Your Ref : MCU/2018/58

RFI RESPONSE MCU/2018/58
202 BAILEYS MOUNTAIN ROAD, UPPER COOMERA (LOT 58 SP191940)

On behalf of our client, Sandson Pty Ltd (the applicant), we hereby provide the following full response to Council's information request dated 9th March 2020.

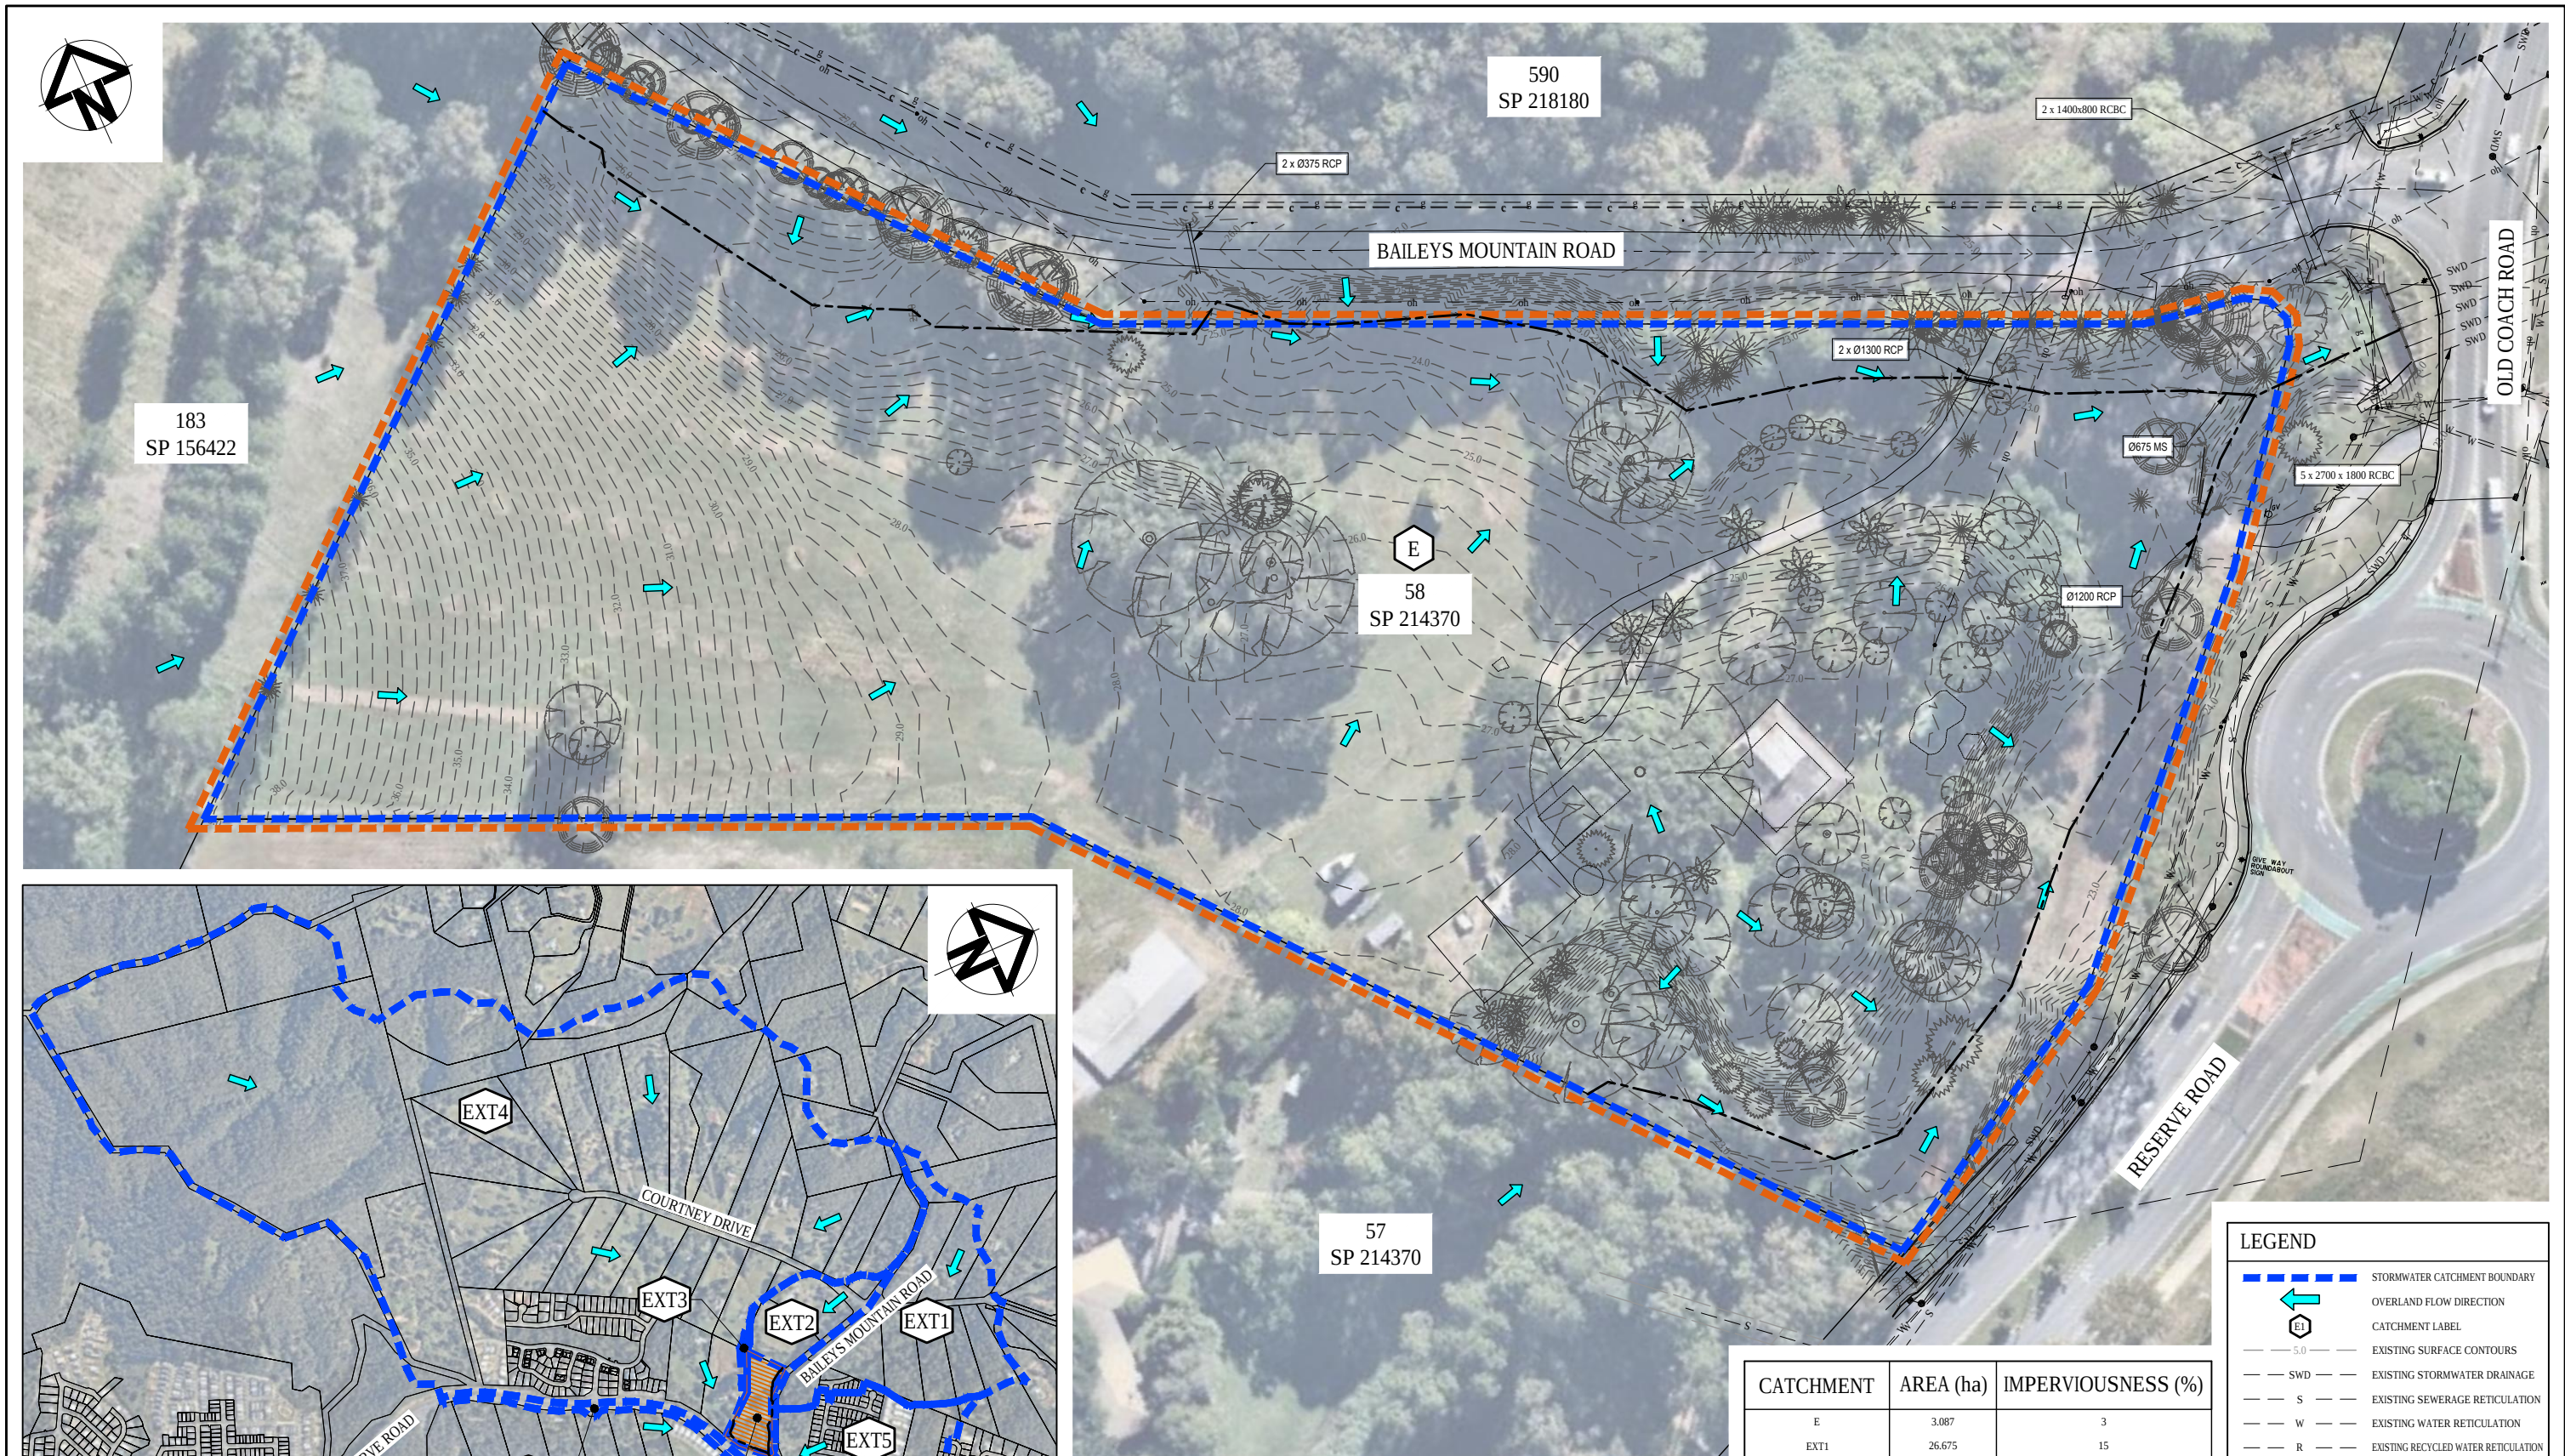
- d) For any overflow on top of the proposed driveway, the applicant is requested to demonstrate that the depth of inundation (d) and depth product velocity ($d \cdot v$) will satisfy the flood safety requirements as per QUDM (e.g., $d \leq 250\text{mm}$, $d \cdot v \leq 0.25\text{m}^2/\text{s}$) by considering necessary blockage of the culverts. Please also undertake a sensitivity analyses of the driveway flood safety hazards by considering 100% blockage of the cross-drainage structure.

The proposed culverts have been designed to ensure that the design storm (100 year ARI storm) is conveyed through the culvert system entirely with adequate freeboard to the driveway. It is further noted, the design for the culverts assumed a 50% blockage factor which is above the standard as noted in QUDM Table 10.4.4. As there is no flow overtopping the driveway during the design storm there is a depth velocity product of $0.00\text{m}^2/\text{s}$.

Project	202 BAILEYS MOUNTAIN ROAD, UPPER COOMERA
Title	BIORETENTION / DETENTION BASIN DETAILS - SHEET 1 OF 2

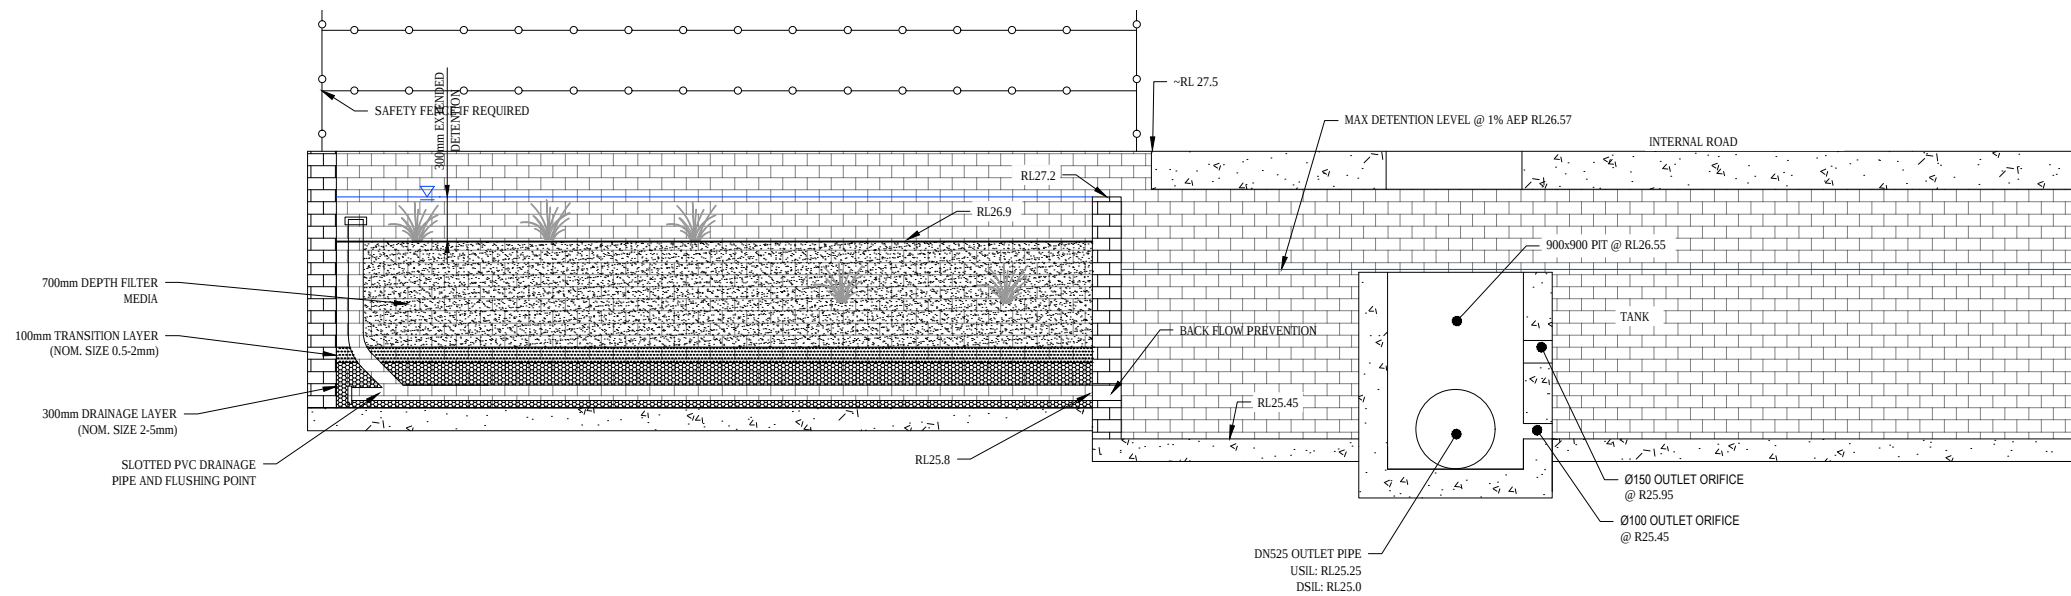
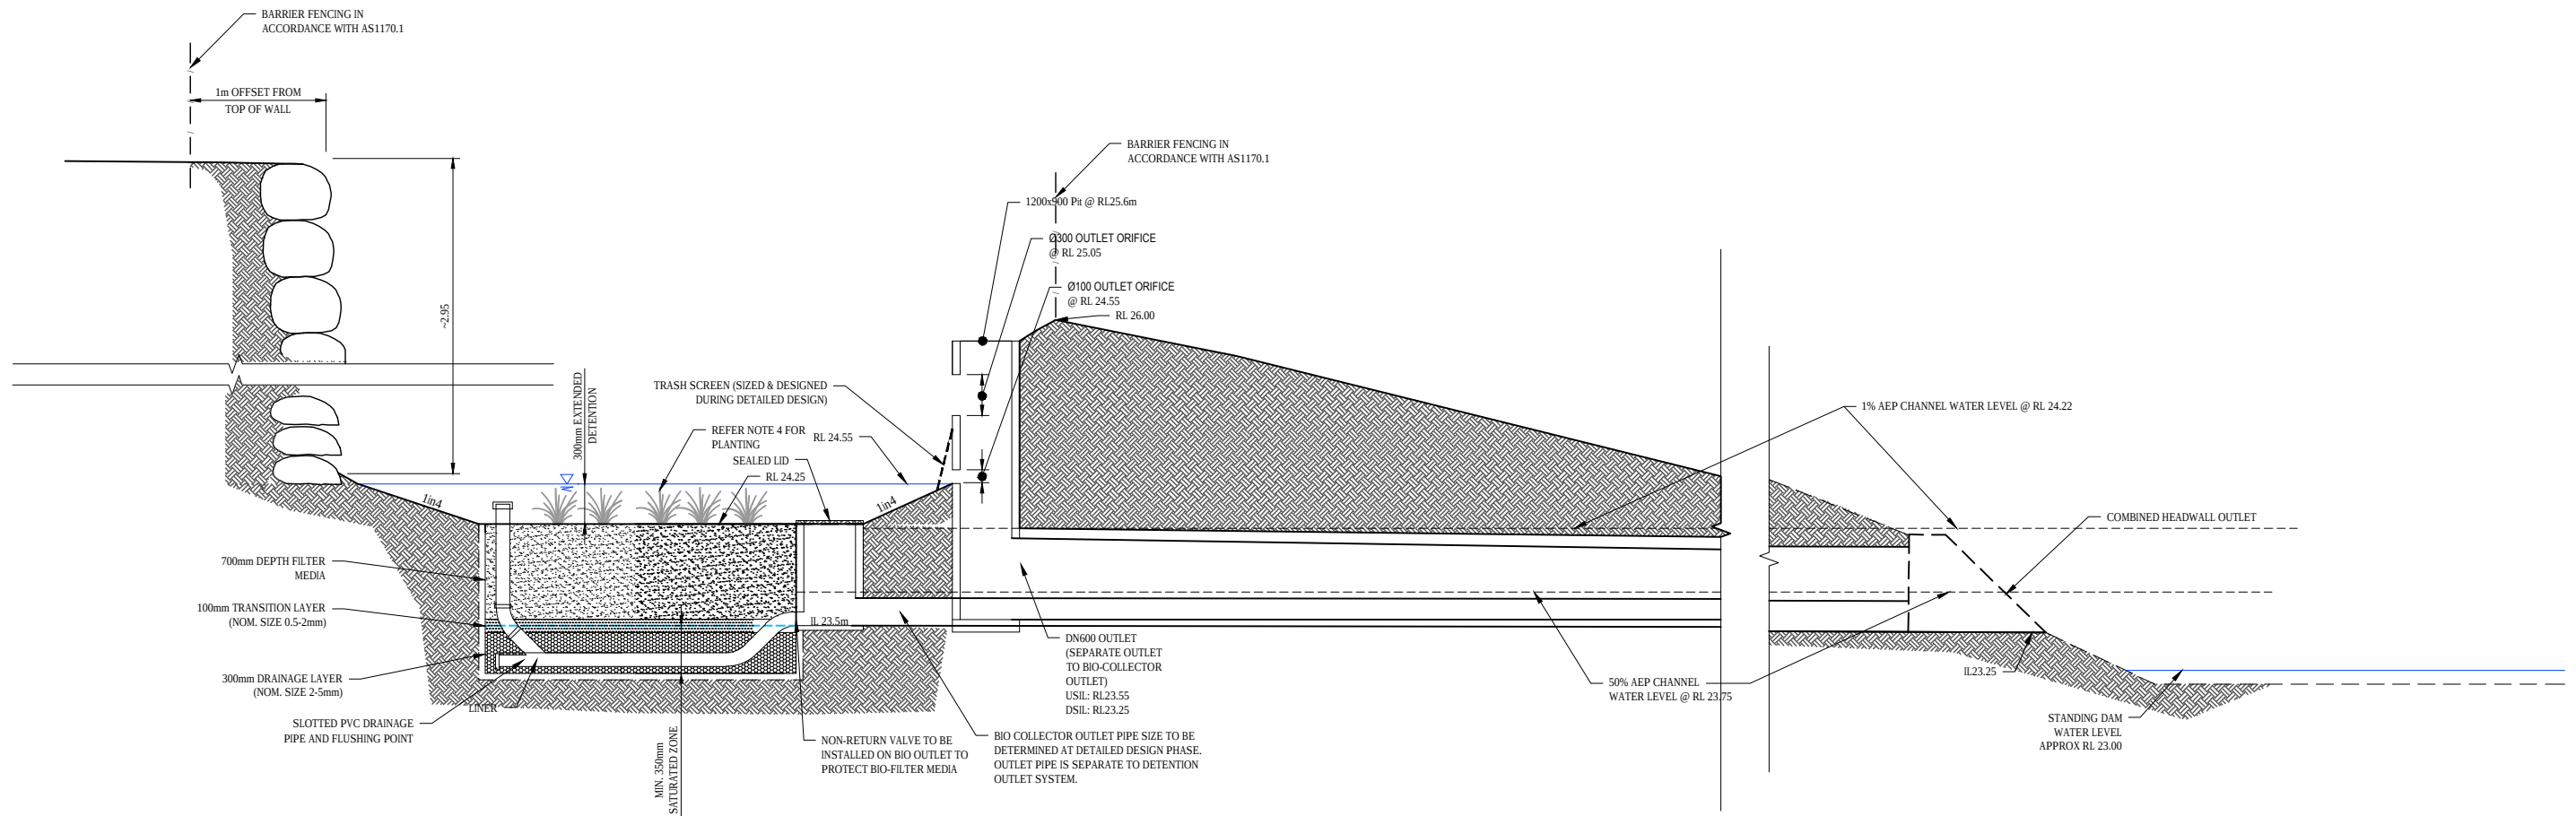
Note: Section 1 - Bioretention / Detention Basin Detail on Sheet DA-00-381 Issue 03 prepared by Arcadis, appears to not be a clear representation of the section line shown on Sheet DA-00-305. This needs to be reviewed and amended to clearly show the detention area and the interface between each element along the section line. It appears the line breaks have been used incorrectly. These should be amended and used where appropriate.

Refer to updated engineering drawings which include a cross section of basin 1 along an east-west alignment and updated sections with amended line breaks.
